| Objection Title:         | Objection #OS005493 - Applicant objection for Reg No:[W0265-01] |

| Reg. No.:  | W0265-01                              |

**Re: Objection under Section 42(3) to the Agency in relation to Notification in accordance with Section 42(2) of the Waste Management Act 1996 as amended, of a proposed determination/decision to grant a licence, subject to conditions, to Clashford Recovery Facilities Limited in respect of the site named Clashford Recovery Facilities LTD, Naul Townland, Naul, Meath, Register No. W0265-01.**

| Ref.  | Details                       | Size | Rev | Scale    |
|-------|-------------------------------|------|-----|----------|
| F 1.0 | Environmental Monitoring Plan | A3   | D   | 1:3,5000 |

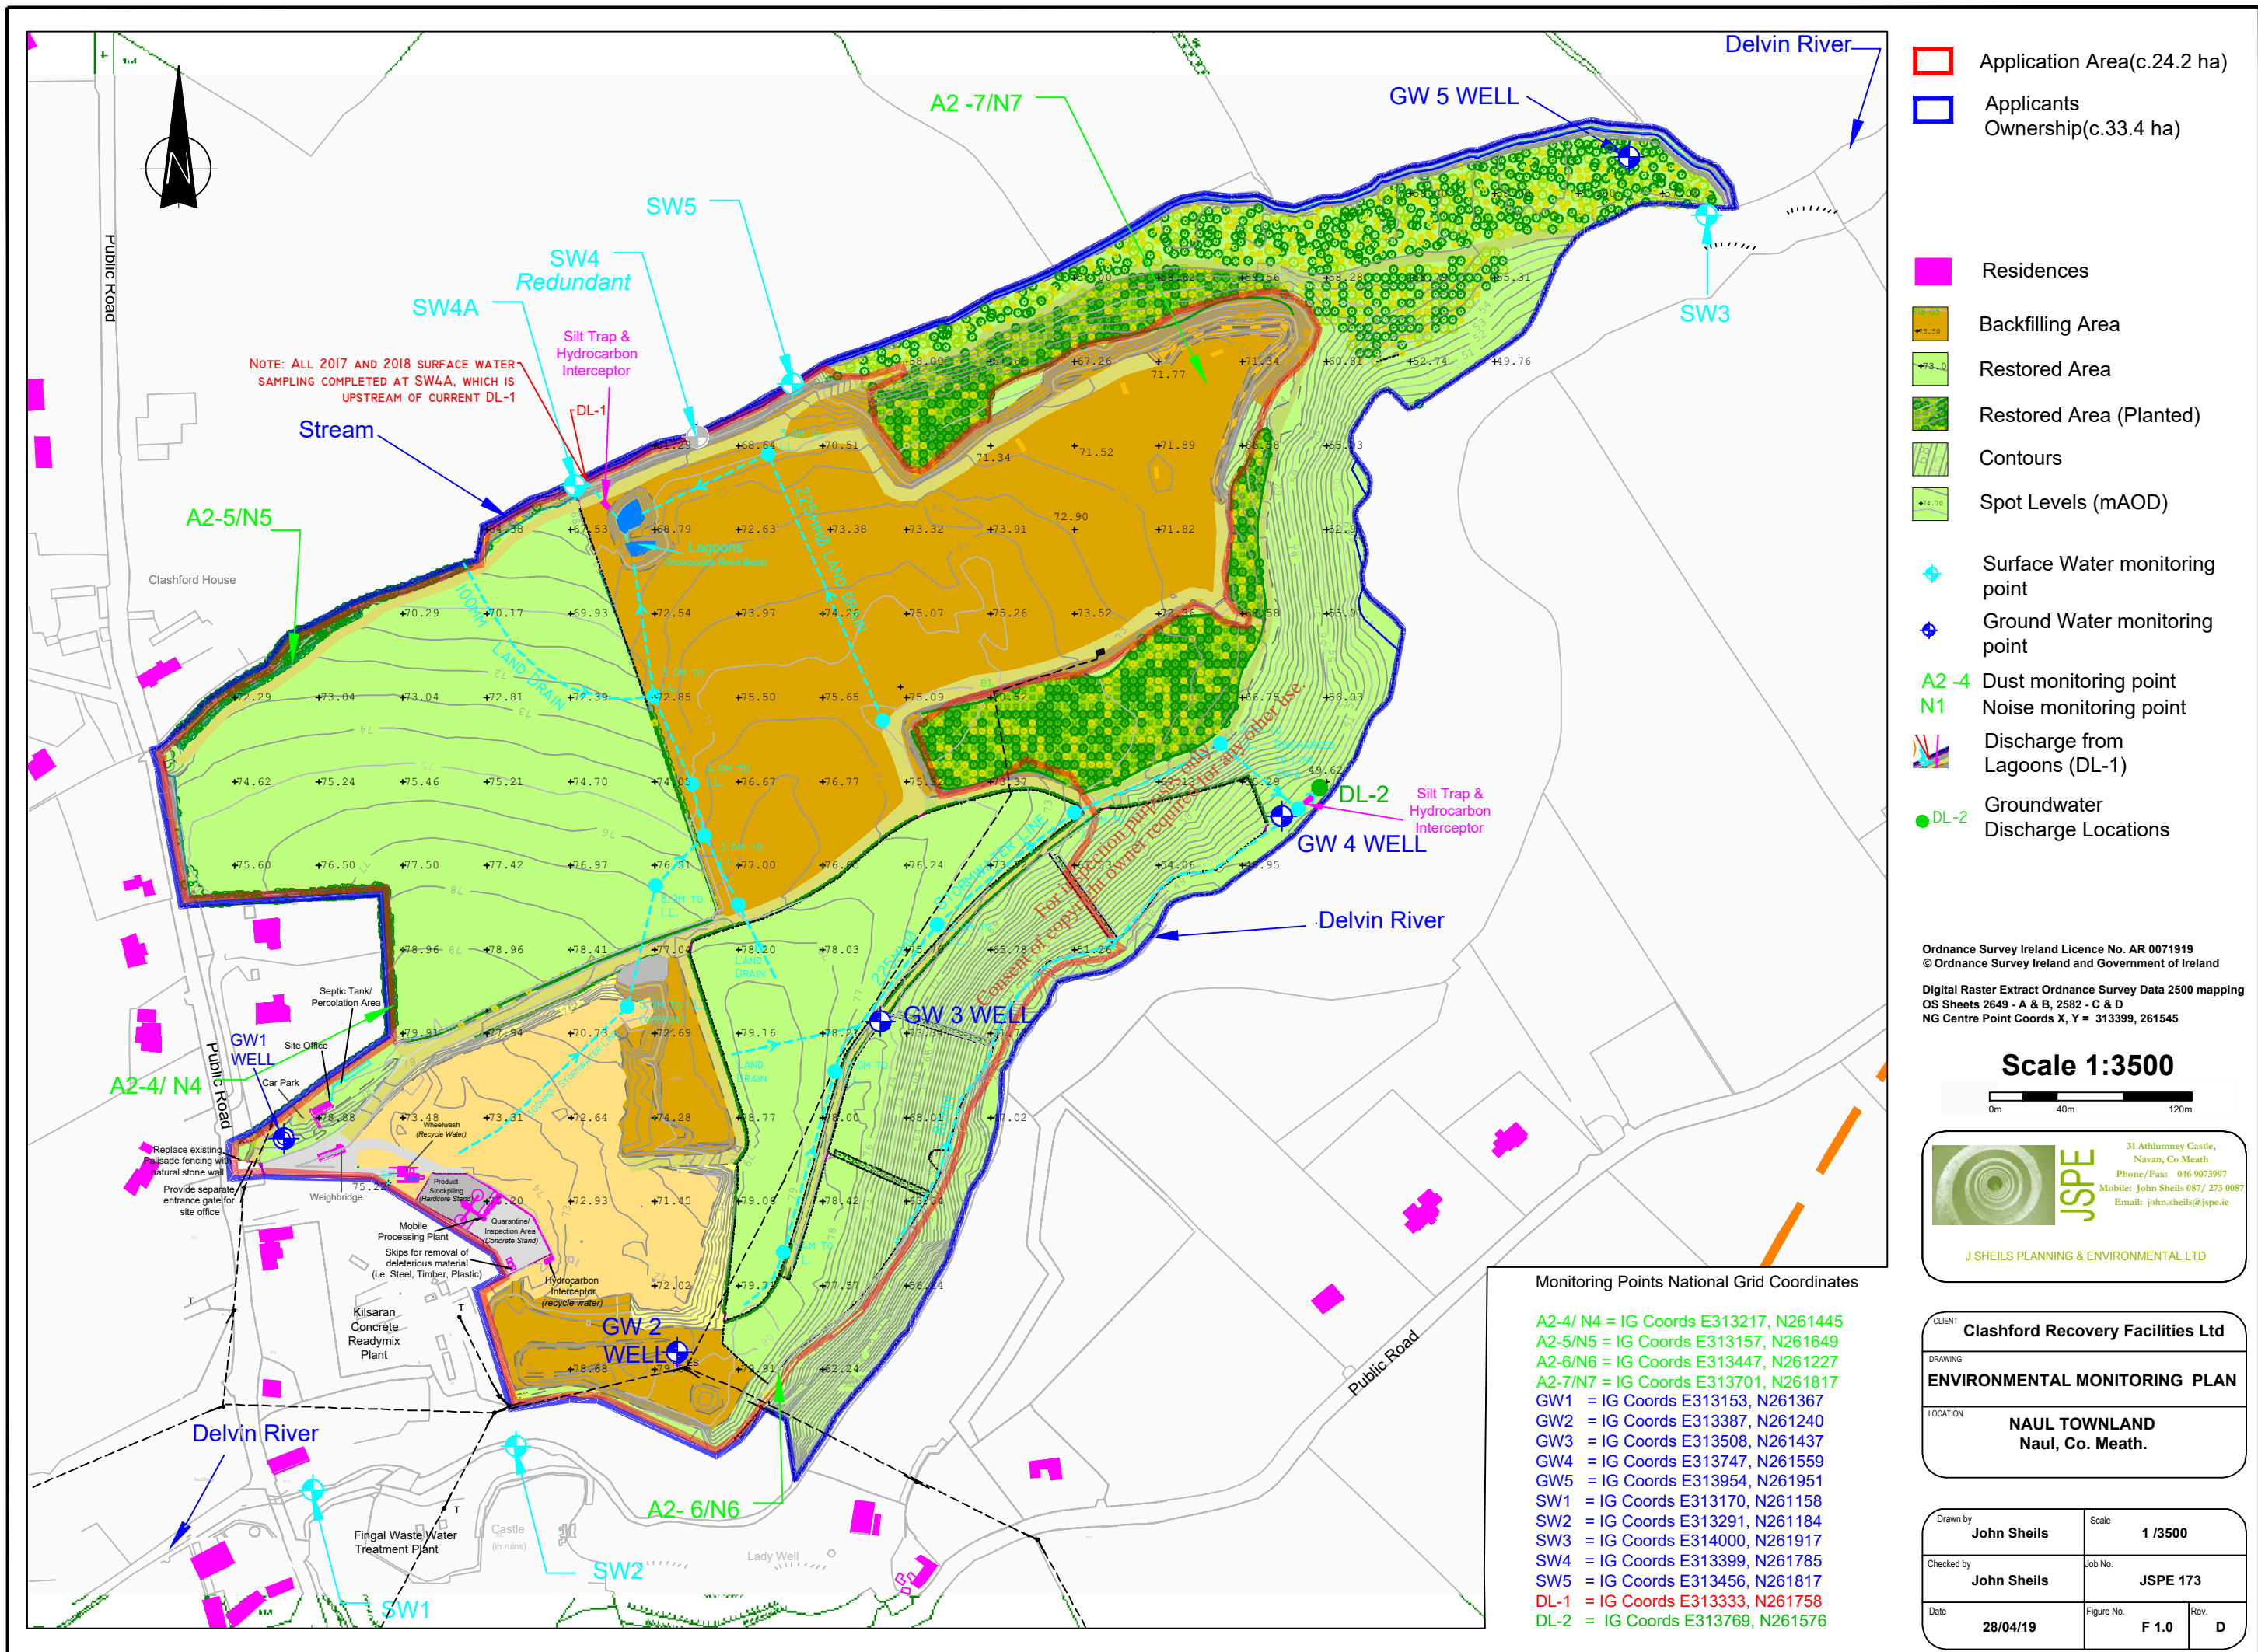
As shown by Figure F\_1.0 Environmental Monitoring Plan dated 8/07/18 Discharge Points DL-2, DL-3, DL-4 are spurs taken from an 80mm land drain running along the bottom of the slope adjoining the River Delvin. In accordance with the above Schedule C.1.1 the EPA have specified that silt traps and interceptors are a requirement to treat the storm water prior to discharge. Our client considers that it would be more appropriate to seal off the spurs and provide a single discharge point as shown by the revised Figure F\_1.0\_Rev\_D. As shown a silt trap and interceptor will be incorporated into the storm water system prior to discharge. As such it is considered that the EPA should amend the schedule accordingly to refer to the single discharge point i.e. DL-2.

It is also note that schedule C.1.2 refers to monitoring at SW4. As shown on Figure F\_1.0 this monitoring point is considered redundant (greyed out) and has been relocated to SW-4A upstream of Discharge Point DL-1. SW5 has been retained being downstream of DL-1. As such it is considered that there is no requirement to carryout monitoring at Location SW4 and this should be removed from the schedule.

As detailed above in relation to *Schedule C.1.1. Control of Storm water Discharges* the applicant is proposing a single discharge point with respect to discharge to the Delvin River (i.e. DL-2); as such we would ask that the EPA amend the above details under Schedule C.1.2 to reflect this.

| DRAWING<br><b>WHEELWASH</b>  |

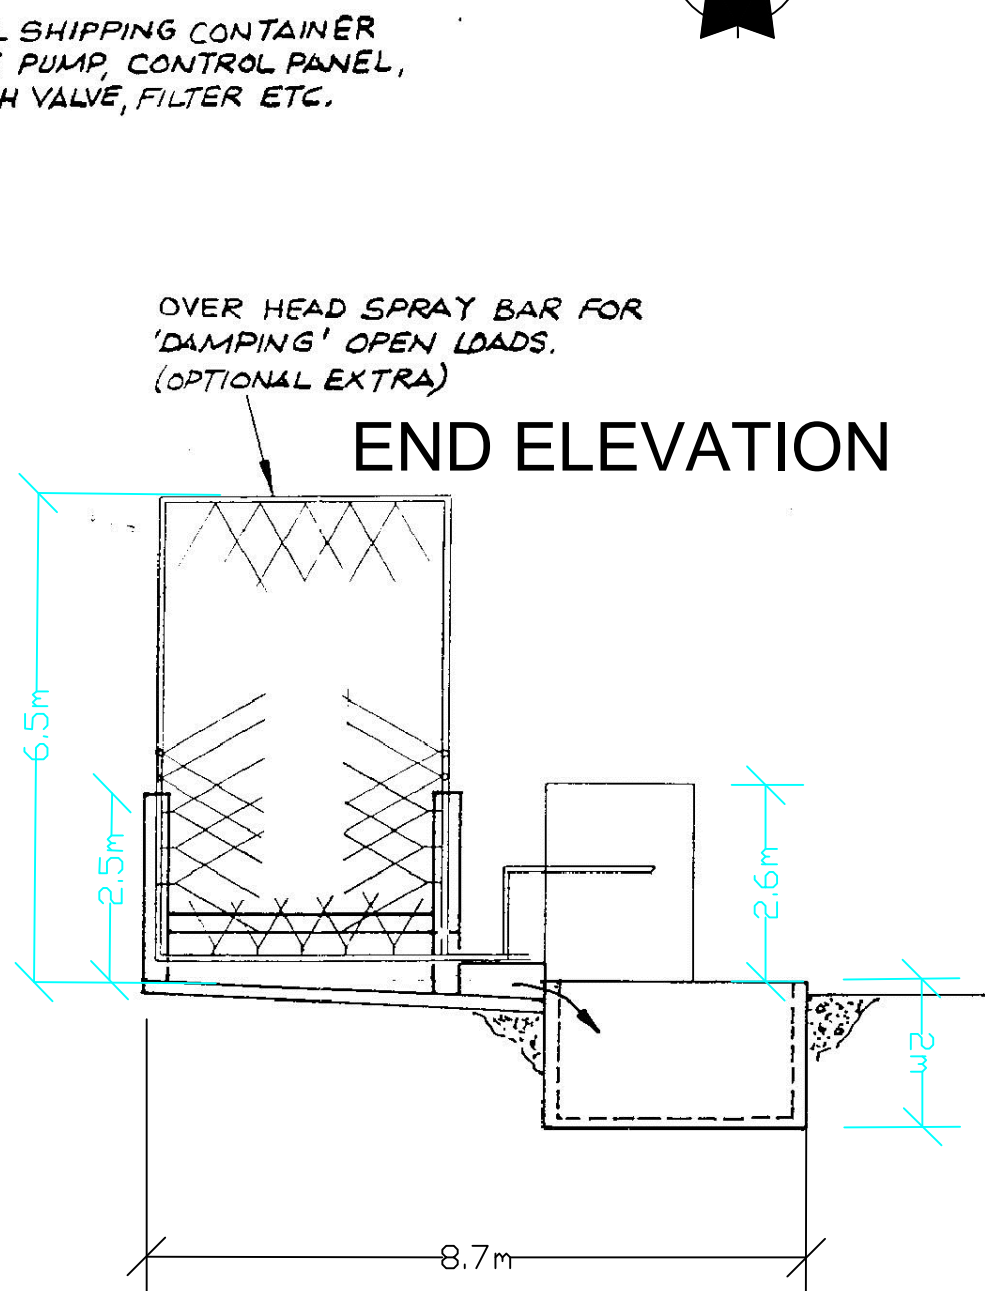
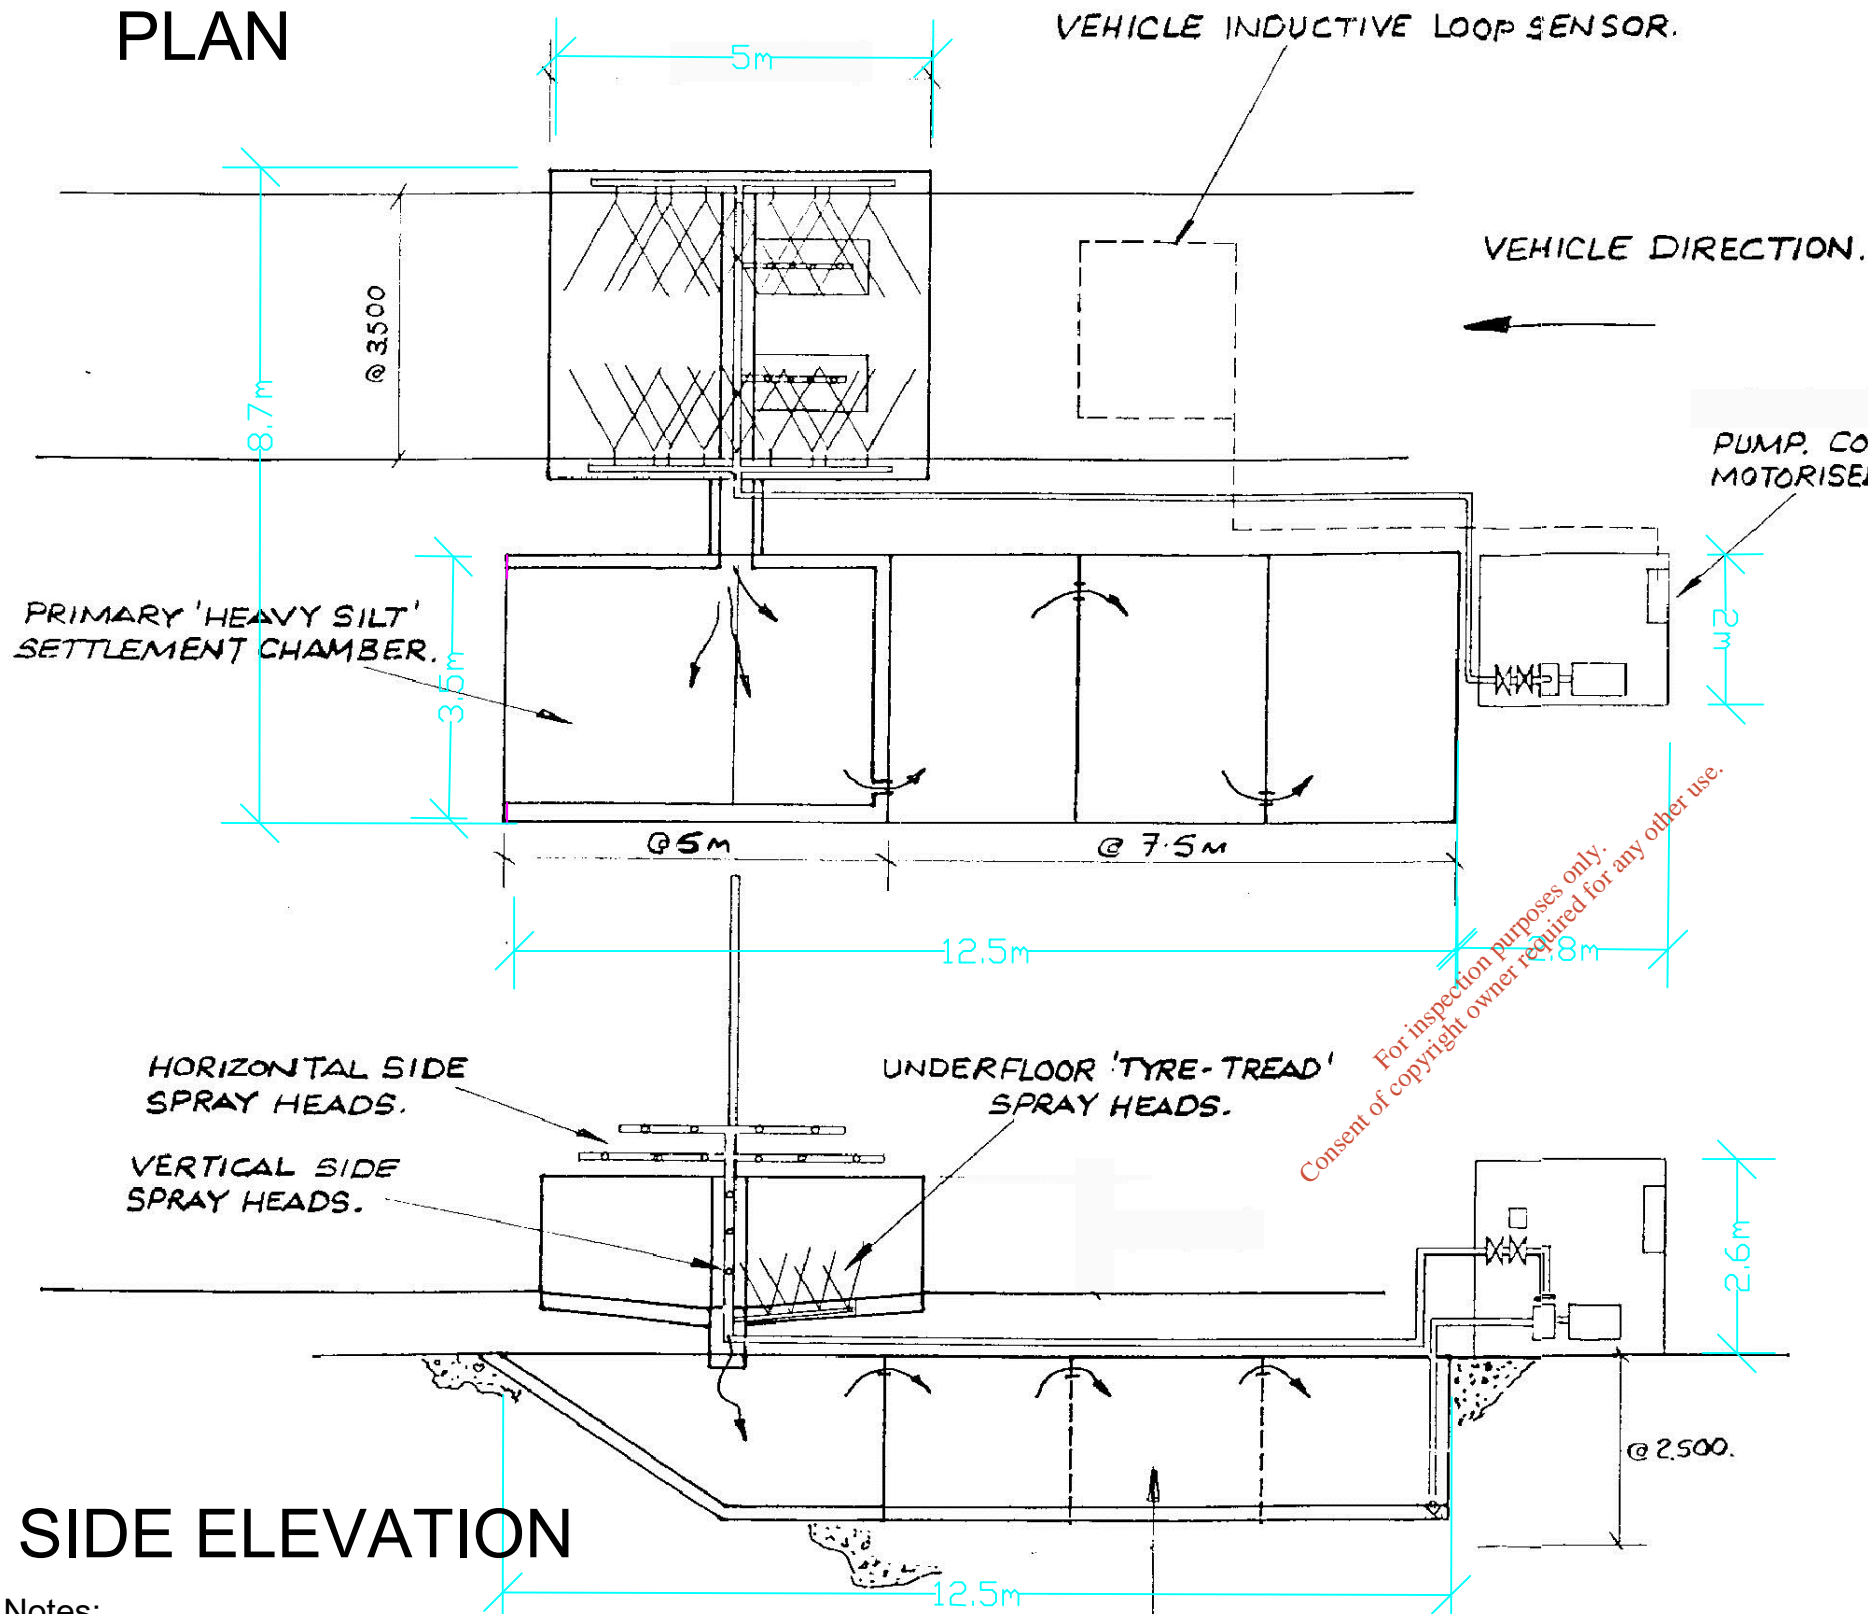
The wheelwash will incorporate settlement and recycling of water. Details of a typical wheelwash incorporating settlement lagoons was provided with the planning application for the C&D Recovery

facility (Refer to Drawing D07 – Copy attached). There shall be no discharge of water from the wheelwash. If the wheelwash requires to be drained the water will be sent for disposal off-site for disposal as per the proposed condition. It is considered the condition should be reworded accordingly to facilitate recycling of water. e.g.

*“All water from the wheel cleaning area shall be recycled. If the wheel cleaner requires to be drained the water shall be sent off-site for disposal”.*
